**Concerned Equipments: ALL RESERVE CANOPIES
Manufactured between 01/01/1987 to 31/02/1989
(Serial Number 87 01 001 to 89 02 XXX)**

CONSERVATORY DECISION

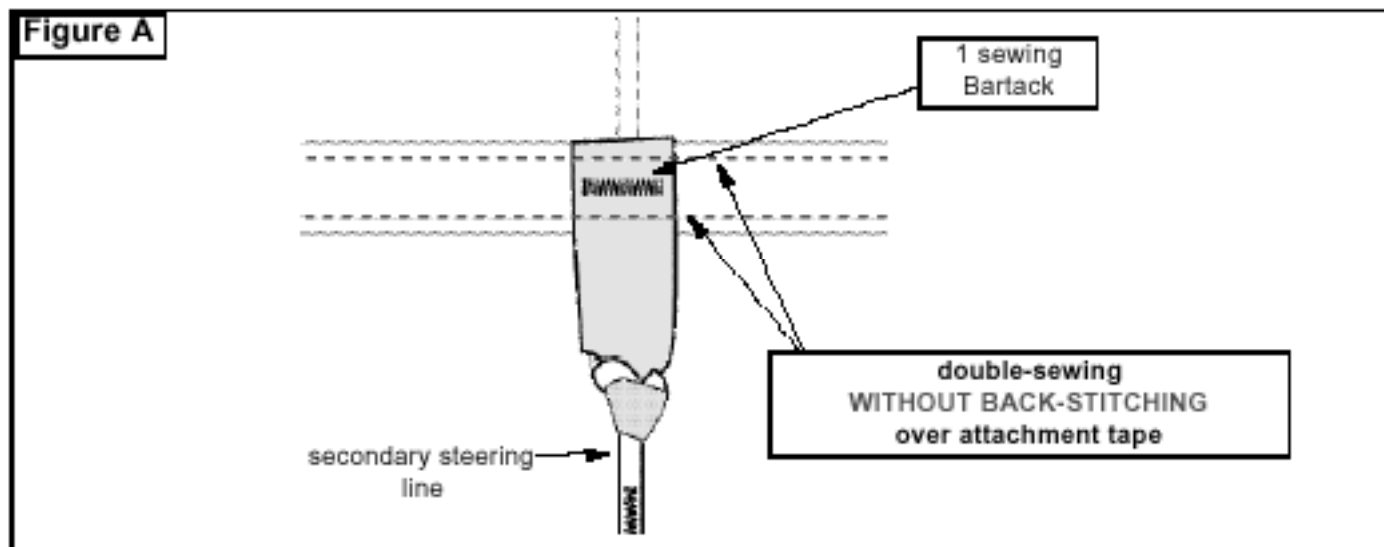
Broken seams located at secondary steering lines trailing edge attachment tapes have been reported on reserve canopy model Minimax 5 (Pn:203).

The assembly of steering lines attachment tapes to trailing edge of the concerned canopy is described by Figure A.

The manufacturing process described Figure A have potentially been used for all others reserve canopies of Parachutes de France from january 1987 to february 1989.

- 1- Detailed inspection by qualified rigger of all stitching pattern at trailing edge for steering lines attachment tapes.
 - Pattern per Figure A as above: immediate grounding even if stitching or fabric are fully undamaged
 - Others stitching patterns: unless damaged, airworthiness is not affected
- 2- Record riggers marks on canopy documents, with "BS PdF N°3-2003, Airworthy" or "BS PdF N°2-2003, Grounded".
- 3- Report to PF S.A. using second page of present Safety Bulletin.
